10/695,985

Douglas Chiang

Office Action Summary

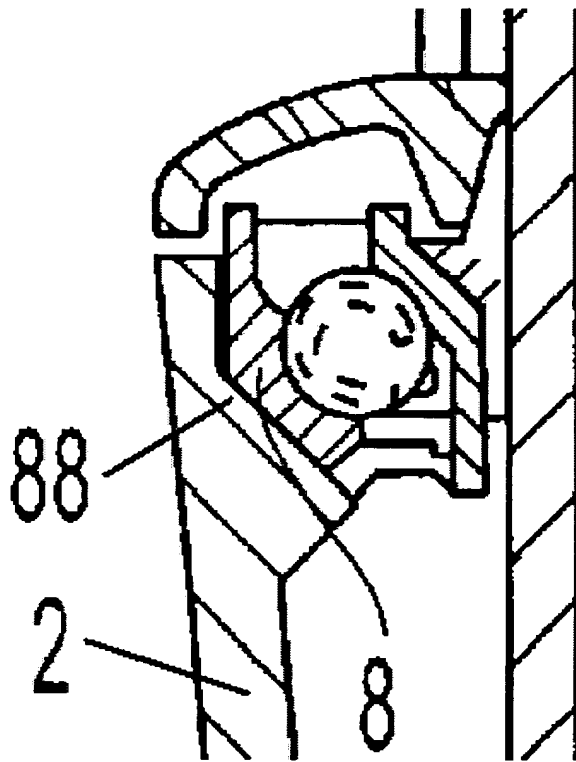
6. Claim 5 is rejected under 35 U.S.C. 103(a) as being unpatentable over Nagano (US 5,272,936) in view of Campagnolo (US 6,431,575).

Nagano discloses a headset assembly for a bicycle, as described in the rejection of claims 1 and 2 above, but fails to disclose the inner periphery of the top end of the

head tube having a tapered surface which matches with the tapered surface of outer periphery of the bearing set.

As shown below, Campagnolo discloses a head tube (2) wherein the inner periphery of its top end is tapered (88) and the outer periphery of the bearing set (8) is also tapered to match the inner surface of the head tube. It would have been obvious to a person of ordinary skill in the art at the time the invention was made to modify Nagano to include a taper on the inner surface of the head tube, and a matching taper on the outer surface of the bearing set, in view of Campagnolo, to better accommodate any trust loads that would be transmitted through the bearing.
